Service Bulletin

SDB-10057649-5812

**SUBJECT: Service Update for Inventory and Customer Vehicles
Body Harness Contact with Park Brake Bracket
Expires with Base Warranty**

**MODELS: 2014-2015 Chevrolet Silverado
2014-2015 GMC Sierra**

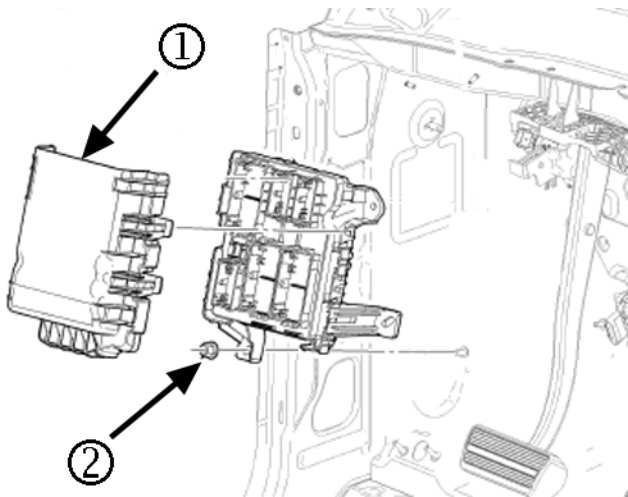
1. Remove the body wiring harness junction block cover (1) located on firewall, right of the park brake assembly. Pull the tabs on either side of the cover to remove.
2. Remove the nut (2) from the junction block bracket.

3. Position the junction block away from the park brake.

4. Locate the fork (1) of the BCM break-out harness from the body harness.
5. Secure the break-out harness away from the park brake bracket by adding the tie strap (2), approximately 25 mm (1.0 in) above the fork.
6. Verify the increased clearance between the harness and the park brake bracket.

7. Reinstall the junction block and install the nut (2). Tighten the nut to 9 N*m (80 lb in).
8. Reinstall the body wiring harness junction block cover (1).
